Wisconsin Department of Transportation

Proposal #07: 8949-00-71, WISC 2021386
Hudson – Baldwin
STH 65 North – USH 63 North
USH 12
St. Croix County

This is Addendum No. 01, which provides for the following:

ADDENDUM NO. 01
8949-00-71/8949-00-74
June 30, 2021

35. Lane Repair, Item SPV.0090.005.

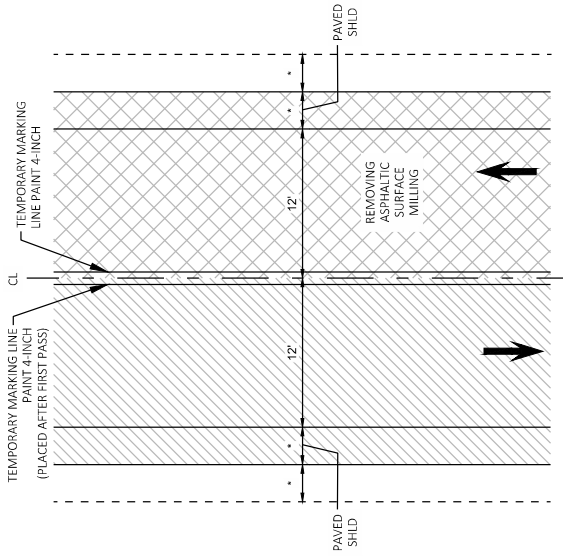
Replace section C Construction with the following:

C Construction

After the surface mill, identify locations unsuitable for supporting the surface HMA Pavement and perform extra depth asphaltic surface milling in accordance with section 204.3 of the Standard Specifications except that the engineer shall determine the location and depth of the extra milling. The extra depth asphaltic surface milling as described under this section must be repaved within 72 hours of being milled. Place asphaltic surface in accordance with section 465.3 of the Standard Specifications to the thickness required to allow for the surface layer of HMA Pavement to be placed above conforming to the plan detail. The asphaltic surface should be allowed to be placed in one layer.

Addendum No. 01
ID 8949-00-71
Revised Sheet 21
June 30, 2021

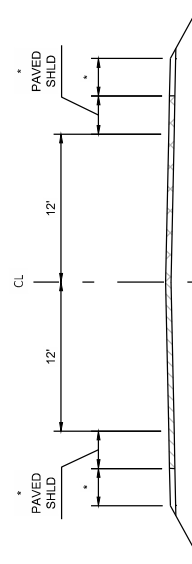
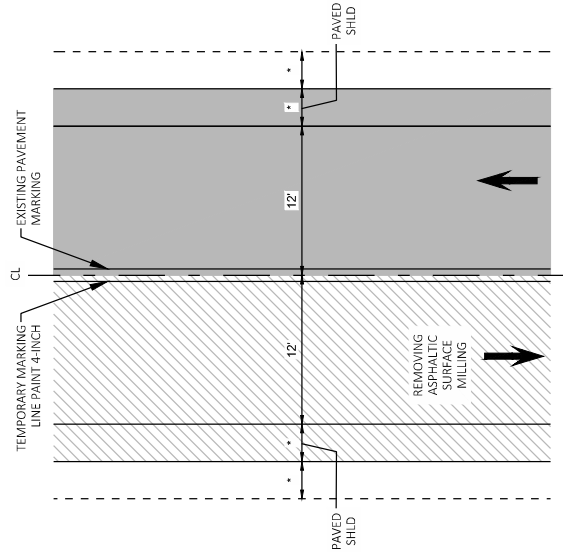
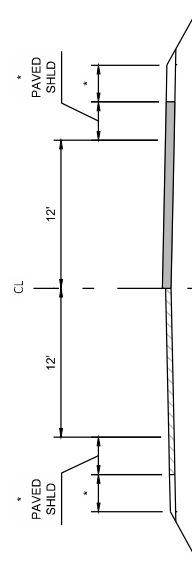
Revised Plan Sheets	
Plan Sheet	Plan Sheet Title (brief description of changes to sheet)
21-22	Construction Detail (Revised to allow milling to C/L)
